Construction Division
Additions & Alteration Charges Approval Form

Company Name:	MRMLLP	Site	Gulmohar Residency
Name of the customer	Uma Shankar Singh		
Villa/ Flat No.	D-604.		
Sl.No	Description	Amount	
1	Total extra Charges	39805	
2	Total refundable amount	-	
3	Net amount to be charges (if any)	39805	
4	Net amount to be refunded (if any)	-	
Remarks :	Extra Charges - towards tiles.		
Thirty Nine thousand Eight hundred and five Rupees only.			
Approved by Project Manager		Approved by Design Team	Approved by MD
Date 02/11/23.		Date	Date
Sign: 		Sign:	Sign:

ATR on Quality Control Check Report. (Apartments)

Quality Control Check Report. Stage: After Finishing Stage III (Apartments)

| QC-B-BLOCK-ELECTRICAL PLAN - FLATS NO 2-~~3~~ TYPE | | | | | | | | | |

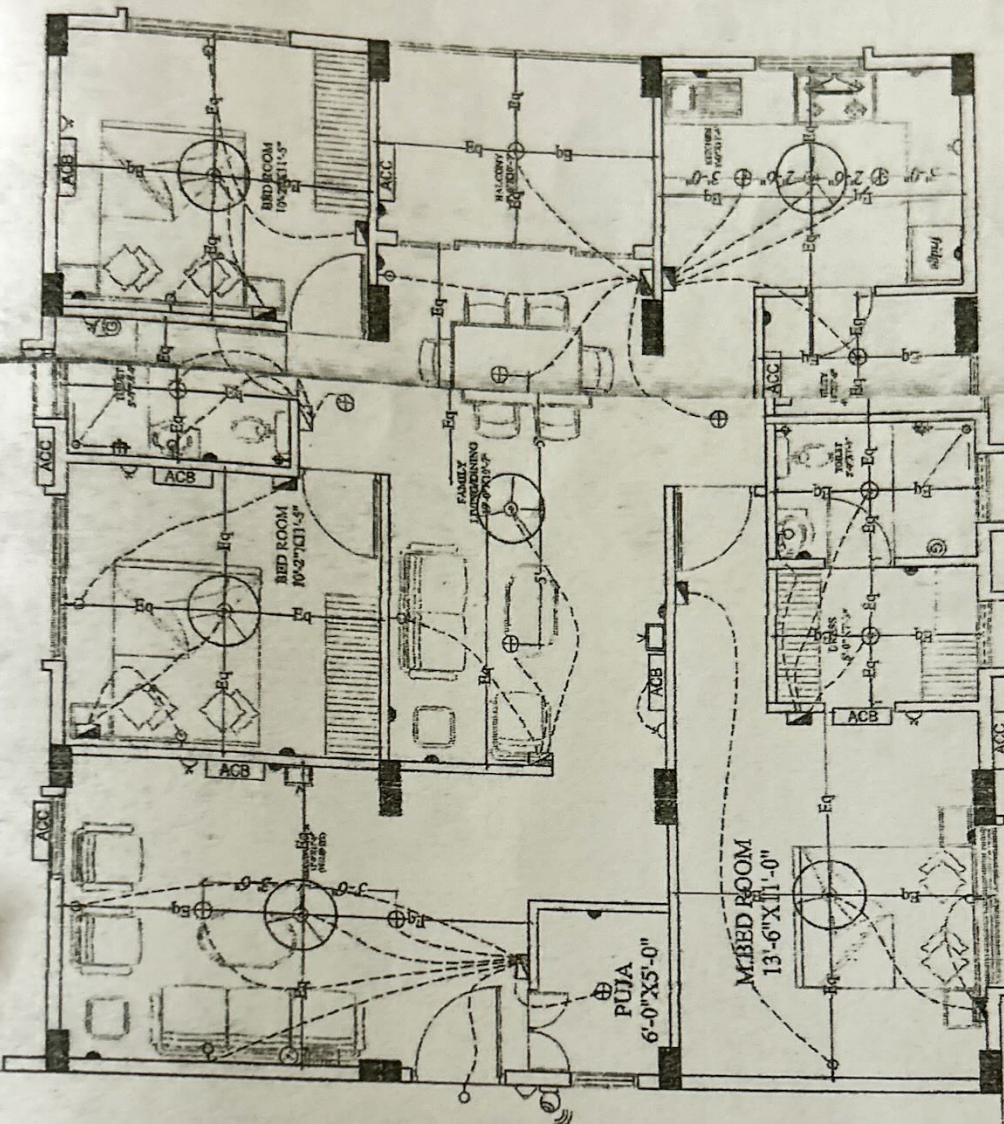
S No	Room	Civil work near pipes in balcony & utility ⁷ (✓ or ✕)	CpVC & PVC Check ⁵ (✓ or ✕)	Electrical points check ⁶ (✓ or ✕)	Water proofing check ⁸ (✓ or ✕)	Proper use of fasteners check ⁹ (✓ or ✕)	Placement of DB ¹⁰ (✓ or ✕)	Placement of Generator changeover (✓ or ✕)
1	Bedroom 1 m-bed	-	-	✕	-	-	-	-
2	Toilet 1 m. Toi	-	✓	✕	-	-	-	-
3	Bedroom 2 c-bed	-	-	✓	-	-	-	-
4	Toilet 2 c. Toi	-	✓	✓	-	-	-	-
5	Bedroom 3 c-bed	-	-	✓	-	-	-	-
6	Toilet 3	-	-	✓	-	-	-	-
7	Drawing	-	-	-	-	-	-	-
8	Dining	-	-	✓	-	-	-	-
9	Lobby 1	-	-	✓	-	-	✓	-
10	Utility / balcony 1	-	-	✓	-	-	-	-
11	Utility / balcony 2	-	✓	-	-	-	-	-
12	Utility / balcony 3	-	✓	✕	-	-	-	-
13	Kitchen	-	-	-	-	-	-	-
14	Other pooja	-	✓	✓	-	-	-	-
15	Other	-	-	✓	-	-	-	-
Remarks								
Note: 1) In m. Toi utility light point missing.

2) without [stage - I] ec-checking, they completed the tiles work in a flat.								
Remarks on additions & alteration sheet:								
Signed by engineer,		☐ Yes ☒ No		Signed by customer,		☒ Yes ☐ No		
Revised drawing required from HO		☐ Yes ☐ No		Approved revised drawing attached		☐ Yes ☐ No

Description	Direction	Owners & Developers :	Date :	Promoted by
PLUMBING PLAN-1660 Sft (B2-TYPE)		Modi Reality Mallapur LLP	04.09.20	Modi Properties Pvt Ltd
		Project Name & Phase :	Prepared By : Jayapradha	Soham Modi
		Gulmohar Residency	Scale :	N.T.S
				Phone: +91-40-66335551

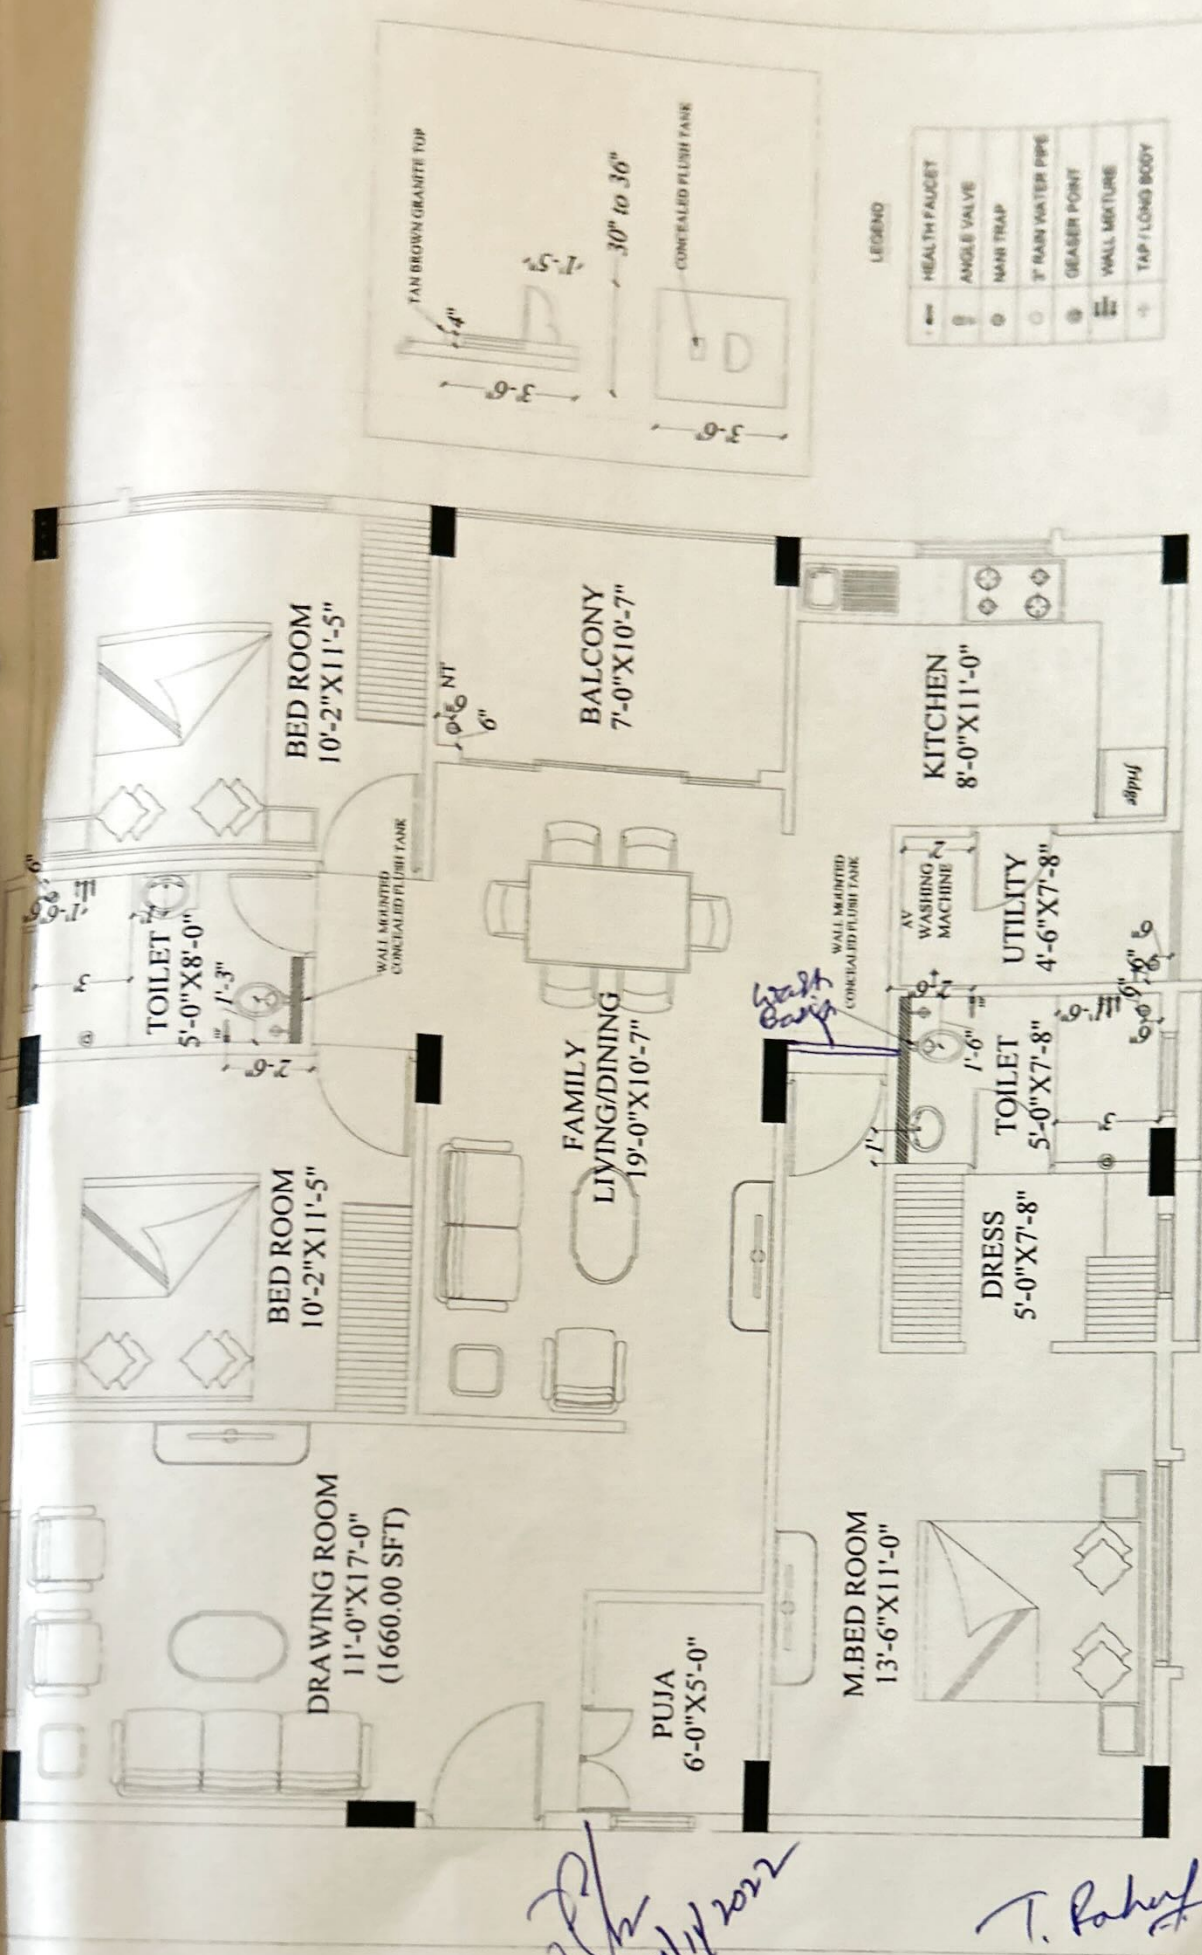
(Changes in electrical points (mark on plan)

Choice of Bathroom tiles, CP fittings & Sanitary ware:

- 1) Master toilet:- ultra Sprinkle
- 2) Common toilet :- ultra Sprinkle
